**1 Products affected**

**3 Detailed description of change**

| 6610 new Cover |            |              |             |                  | 0118.2112 |        |

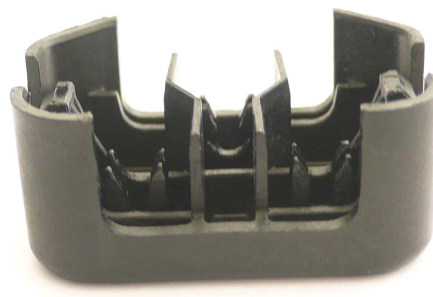
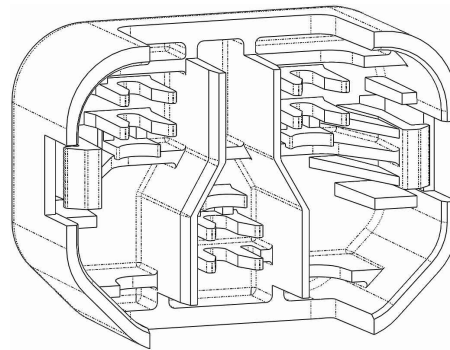
To ensure the fixation of the wires, especially for smaller size of conductor, a support on the Cover is necessary.

The fixation is visible only from the inside of the Cover.

The change gives security if smaller sizes of conductors are used.

Form: Fixation on the Cover  
Fit: n/a  
Function: Fixation of smaller conductors  
Production Site: n/a  
Product Label: n/a
